Acoustic Design Review

30 Queen Victoria Street, Reading, RG1 1TG

Clement Acoustics has been commissioned by ERS Consultants Ltd to undertake an acoustic design review relating to the proposed development at 30 Queen Victoria Street, Reading.

Figure 3.1 Section view showing existing timber joist area and removed suspended ceiling

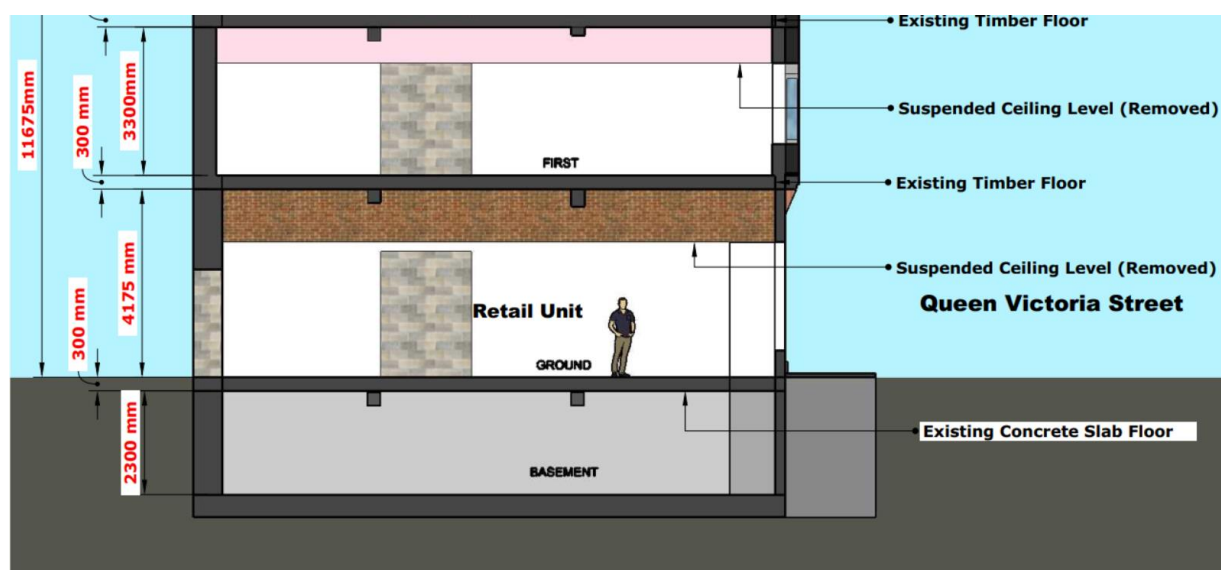
Section drawings drawn by Ian Benbow indicate that the separating floor is based on retained 300 mm timber joists, with existing suspended ceilings to be removed. Relevant parts of the section drawing are shown in Figure 3.1.

In order to provide a floor construction that is suitable for the intended use, we would recommend removing the suspended ceiling and constructing a new independent ceiling below a primary plasterboard ceiling.

We would recommend installing mineral wool, density 45 kg/m³, within the 300 mm timber joist void to a thickness of half the void depth. We would then recommend lining the joists with a double layer of dense plasterboard, to provide a total mass per unit area of at least 25 kg/m².

Figure 3.2 Section view of proposed separating floor treatment

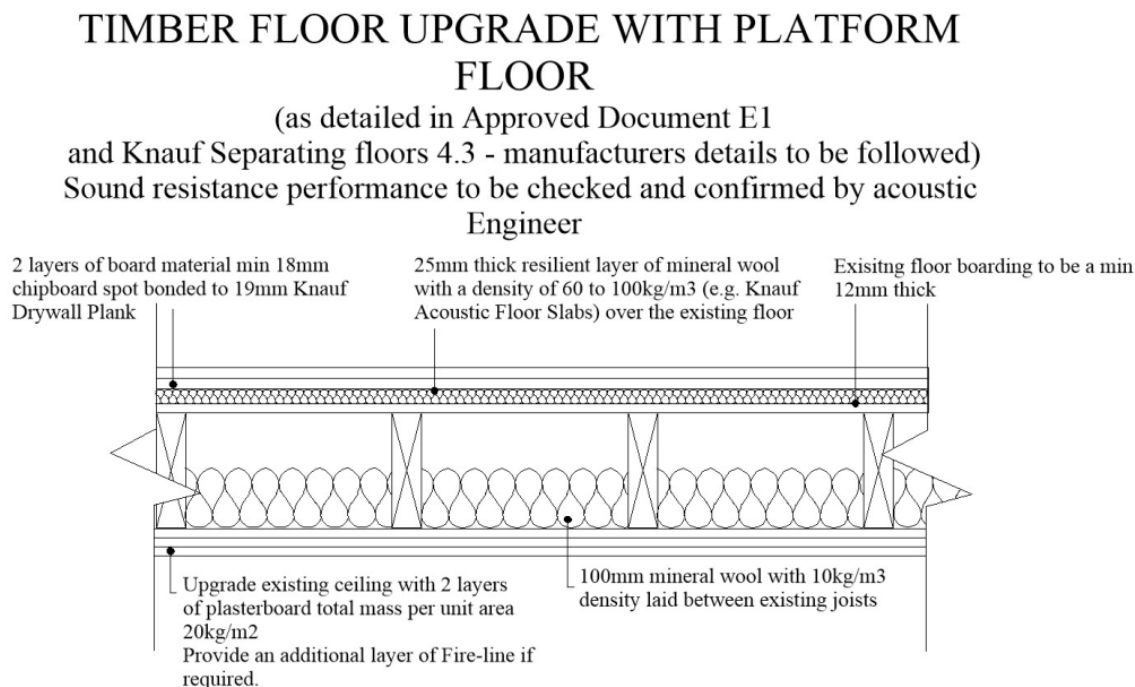
The Building Regulations Specification document, issued by Ian Benbow, indicates that proposed works to separating floors will be undertaken in accordance with Floor Treatment 2, as defined in Diagram 4.6 of ADE.

It should be noted that in previous projects, separating floors designed in accordance with ADE Floor Treatment 2 perform poorly, and often fail to meet the minimum requirements for residential floors. It is therefore considered that the floor treatment would be sufficient, particularly where an uplift for the commercial use is proposed.

We would then recommend installing a secondary, independent ceiling below the primary ceiling, with new timber joists supported from surrounding walls only. It is anticipated that timber joists a minimum of 175 mm deep would be required, and a minimum 25 mm separation between the primary ceiling and secondary joists is recommended.

We would recommend installing 100 mm mineral wool, density 45 kg/m³ between the joists, before lining the secondary joists with a single layer of 15 mm SoundBloc plasterboard or equivalent.

It should also be ensured that the timber deck at first floor level is a minimum of 14 kg/ m².

Figure 3.3 Section view of proposed separating floor build up

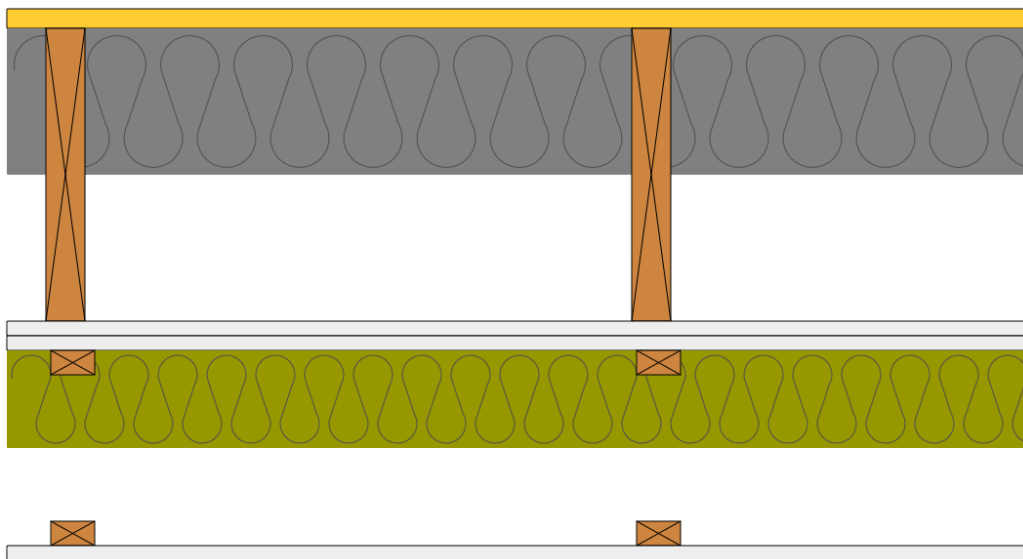
The proposed construction has been modelled using proprietary sound insulation software INSUL, with a section view shown in Figure 3.3. It should be noted that INSUL represents independent joists as separate joists at the top and bottom of the void, whereas in reality there will be larger joists at the bottom edge of the void only.

The modelling exercise indicates a predicted laboratory sound insulation performance of $R_w + C_{tr}$ 67 dB. Allowing for typical onsite factors including flanking noise and workmanship limitations, the predicted sound insulation performance is therefore in the region $D_{nT,w} + C_{tr}$ 57-62 dB.

The predicted level of sound insulation is therefore inline with the recommended design target; however, the level of noise transmission into residential spaces must also be considered.
